CONCEPTUAL GRADING PLAN FOR
 LAND LOT 422, 18th DISTRICT, SECTION 2, COBB COUNTY
 6527 Peach Drive - Suite 400
 Marietta, Georgia 30066
 Phone: (770) 426-7711
 Fax: (770) 426-7711
 www.blackwell-engineers.com
 Chastain Project - 10/1/2006 - CONTRACT 10/06/06

APPLICANT: Heritage Hospice

PETITION NO.: Z-8

Z-8 HERITAGE HOSPICE

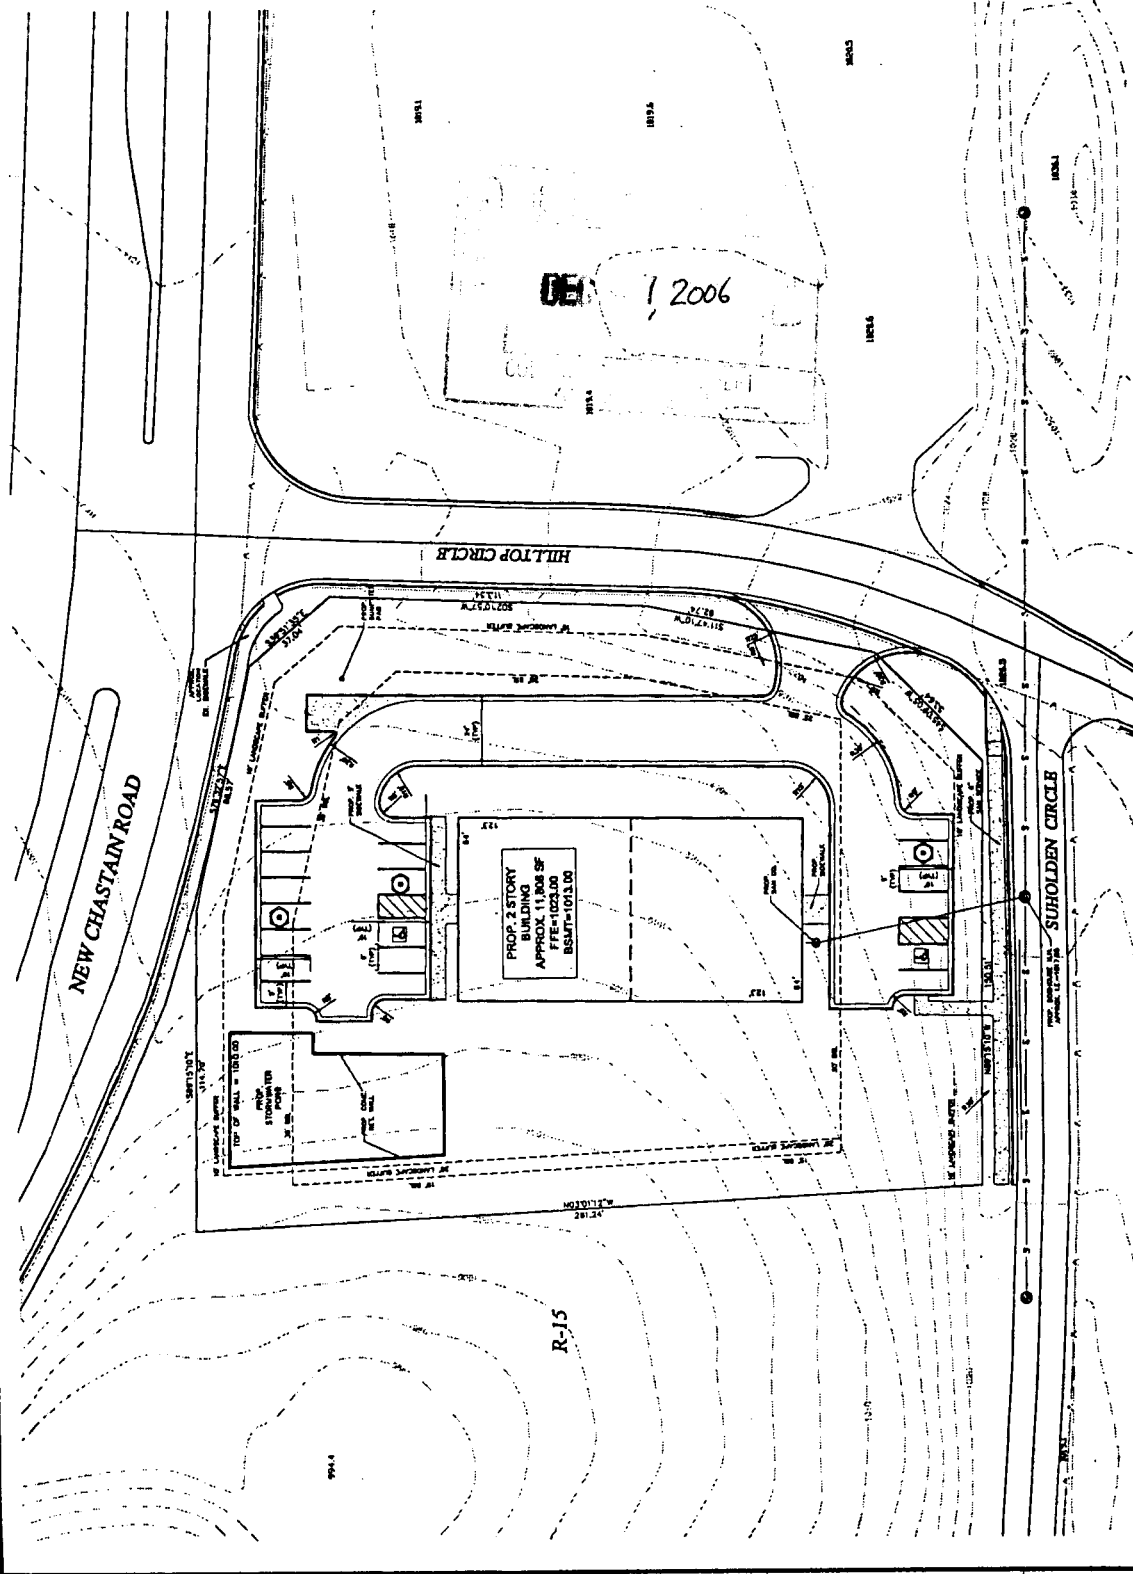
- ☐ Provide comprehensive hydrology/stormwater controls to include development of out parcels.
- ☒ Submit all proposed site improvements to Plan Review.
- ☐ Any **spring activity** uncovered must be addressed by a qualified geotechnical engineer (PE).
- ☐ Structural fill _____ must be placed under the direction of a qualified registered Georgia geotechnical engineer (PE).
- ☐ Existing facility.
- ☒ Project must comply with the Water Quality requirements of the CWA-NPDES-NPS Permit and County Water Quality Ordinance.
- ☐ Water Quality/Quantity contributions of the existing lake/pond on site must be continued as baseline conditions into proposed project.
- ☒ Calculate and provide % impervious of project site.
- ☐ Revisit design; reduce pavement area to reduce runoff and pollution.

1. This entire site drains to the west through an adjacent residential parcel to an existing detention pond located on this lot. The dam for this pond appears to be owned by Cobb DOT. Any stormwater impacts to this existing structure must be addressed with Cobb DOT and the adjacent property owner. From this pond the receiving stream flows north parallel to New Chastain Road to the detention pond for Chastain Ridge S/D. Storage routings must be performed during Plan Review as part of the site hydrologic analysis to verify no adverse impacts to these two ponds.
2. Adequate landscaping or natural buffer must be provided to screen the proposed detention pond from the adjacent residential property and New Chastain Road.
